APPEAL SUMMARY

Status: Decision Rendered - Reconsideration of ID 22236

Appeal ID: 23418	Project Address: 1518, 1520, 1522, 1524 N Blandena St
Hearing Date: 2/5/20	Appellant Name: Paul Wolfe
Case No.: B-012	Appellant Phone: 5039543065
Appeal Type: Building	Plans Examiner/Inspector: Geoffrey Harker
Project Type: commercial	Stories: 4 Occupancy: R-1 Construction Type: V-A
Building/Business Name: Homestead at Pittman Park Hotel	Fire Sprinklers: Yes - NFPA 13 Throughout
Appeal Involves: Reconsideration of appeal, occ Change from R-2 to R-1	LUR or Permit Application No.: 19-122517-CO
Plan Submitted Option: pdf [File 1]	Proposed use: Transient Dwelling (Hotel/Motel)

Homestead at Pittman Park Hotel
1518 N Blandena Street, Portland, OR 97217

1
A-2 Proposed Ground Floor Plan
Scale: 3/32" = 1'-0"

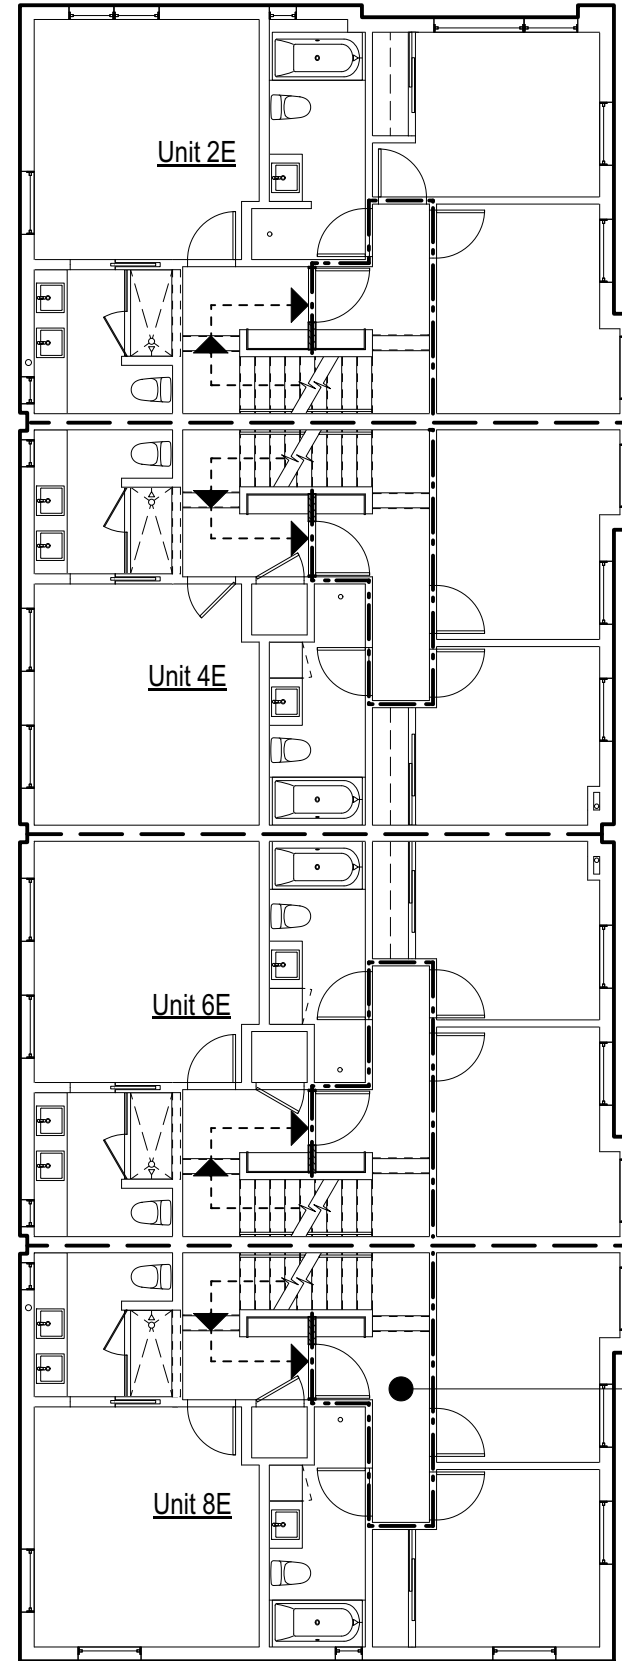
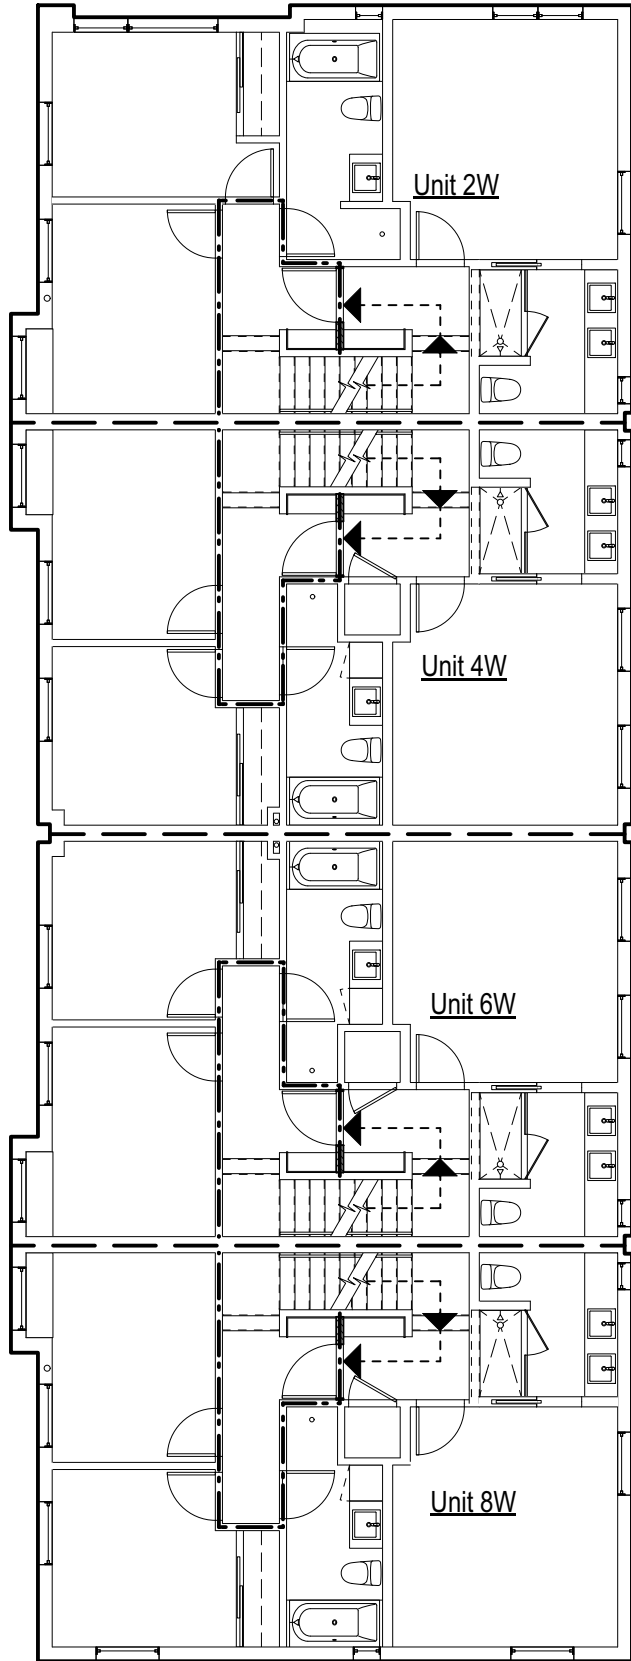
Proposed project configuration is a 2-building, 4-story 16 unit R-1 motel permitted under the commercial code (2019 OSSC). The garage + bonus room of each existing unit (8x) will be converted to a separate 1-bedroom R-1 unit. New kitchens, bathroom modifications, and reconfiguration of interior partitions will accommodate the new units.

Second Exit for 4-story unit

New 1-hr horizontal separation;
Typ. at ea. new ground floor unit

Existing/Proposed Second Floor Plan
Scale: 3/32" = 1'-0"

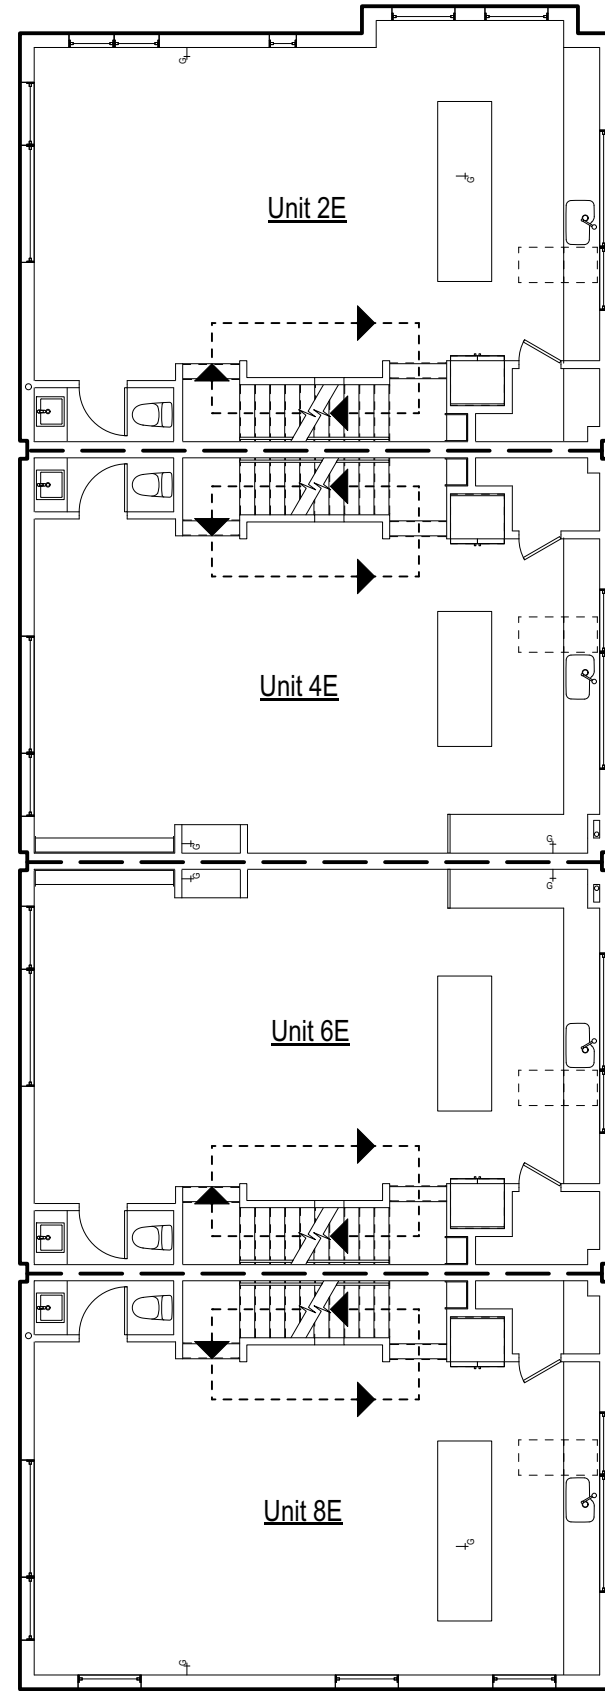
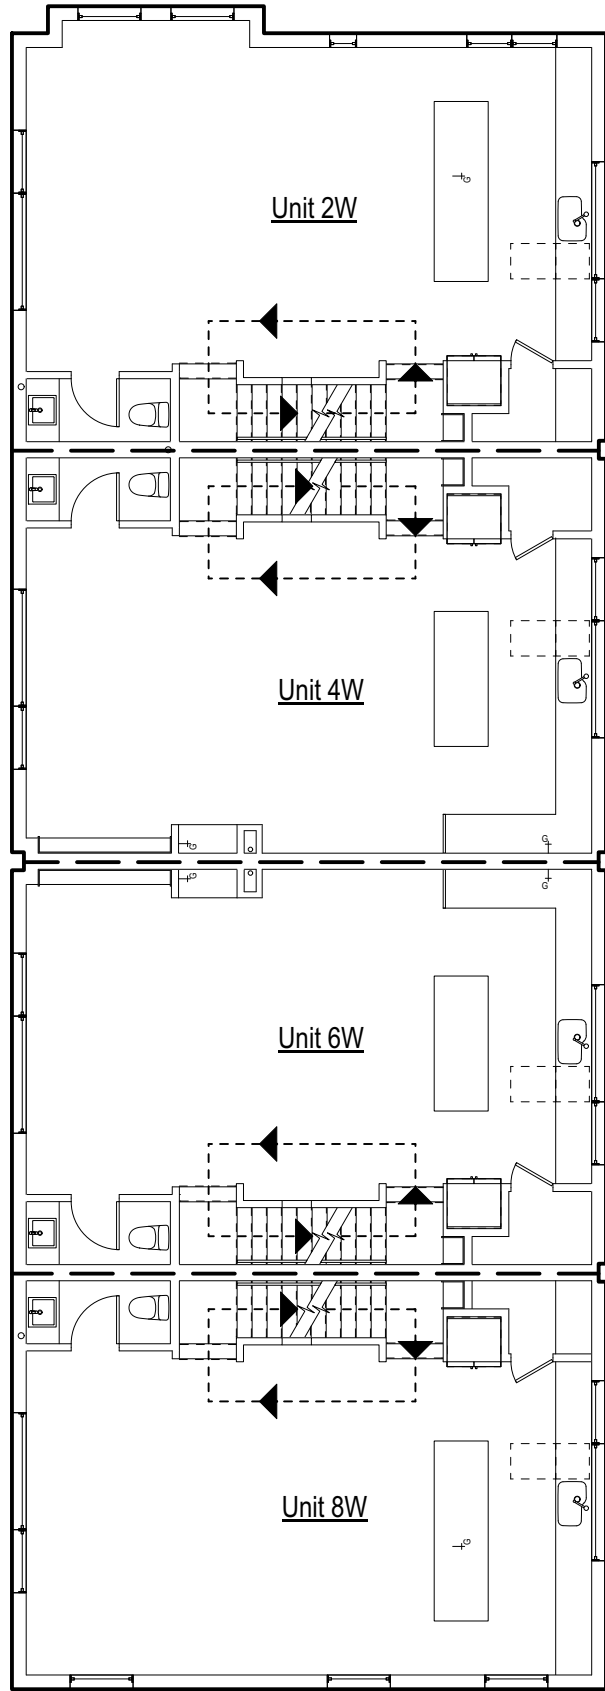
New 1-hr rated stair enclosure from the mid-point of the second floor down to the ground floor exits.

New 1-hr rated exit stair enclosure; typ. to ground floor

Increase in maximum allowable exit access travel distance in all 4 units: Granted provided a monitored alarm system is installed that includes smoke detection in the stairs at the 1st and 2nd levels and 1 notification device in the stairs at levels 1, 2, 3 and 4 and provided no bathroom opens into the stair enclosure, and provided there is no storage in stair enclosure and provided space below stairs is not

1 Enlarged Typical Unit Floor Plans
A-6 Scale: 3/32" = 1'-0"

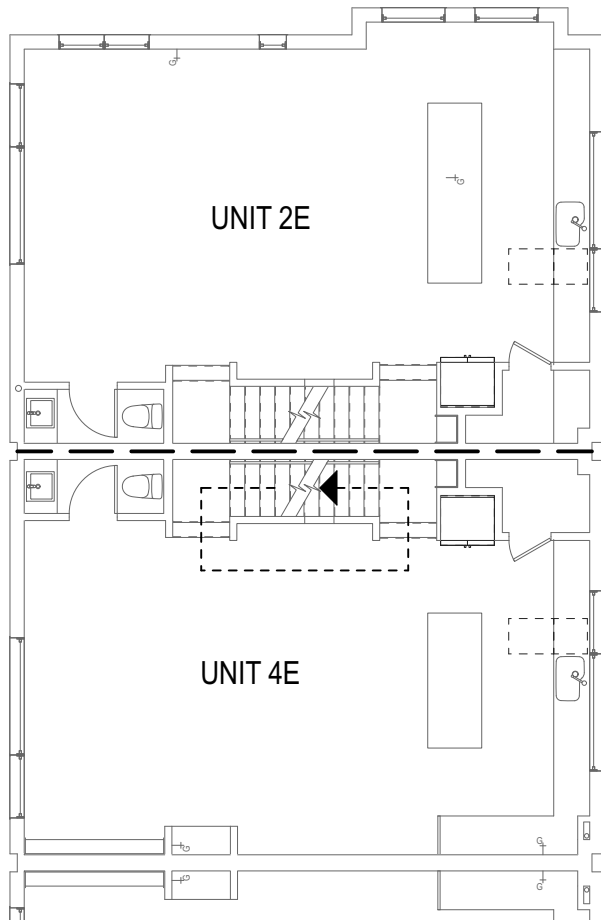
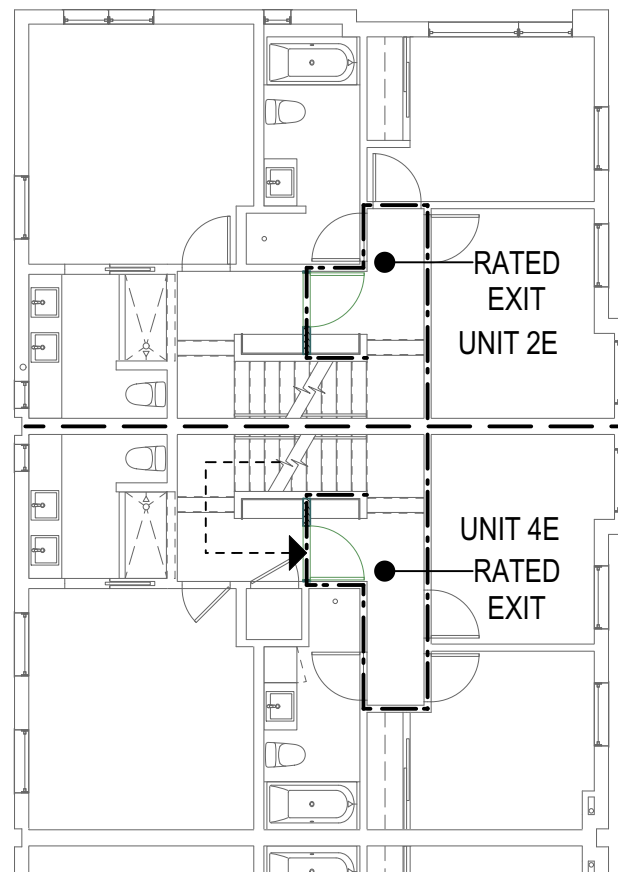
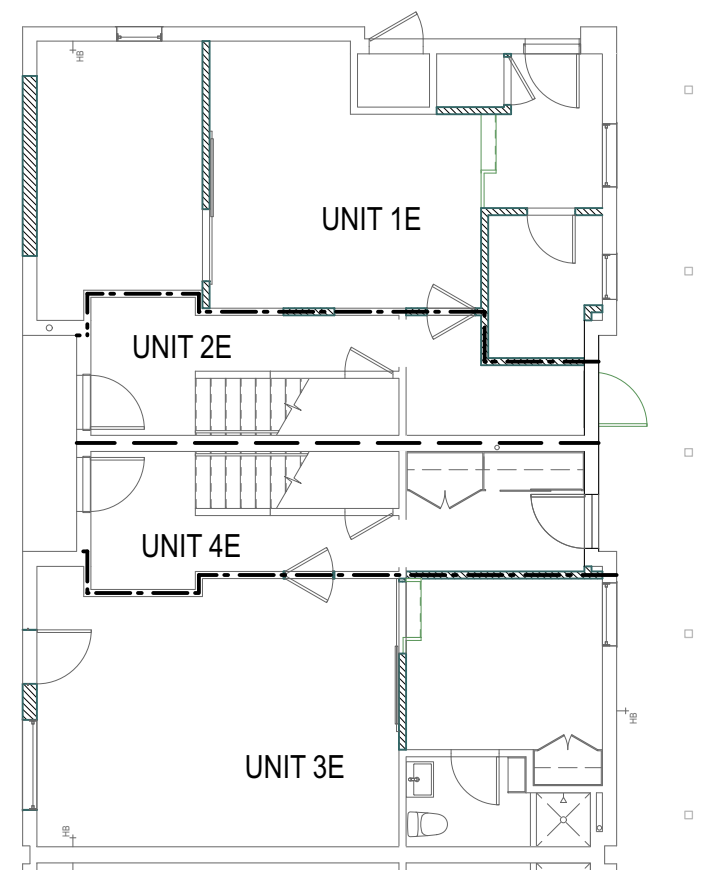
- Max Travel Distance - 90' @ Building A (shown)
- 90'-10" @ Building B

- Existing Stair to be 1-hr rated from mid-second floor down to exterior exit doors on ground floor. The newly rated stair will have a door on a magnetic hold-open tied to the fire sprinkler system on the second floor.
- Upgrades will be made to existing doors and walls/ceilings to ensure full 1-hr rating.
- No change to (E) 2-hr demising walls

- 2 ground floor Exits from 4-story R-1 units.
- Communicating Hotel-style rated doors between 4-story and 1-story units; doors to facilitate multi-unit rental - locked from ea. side.
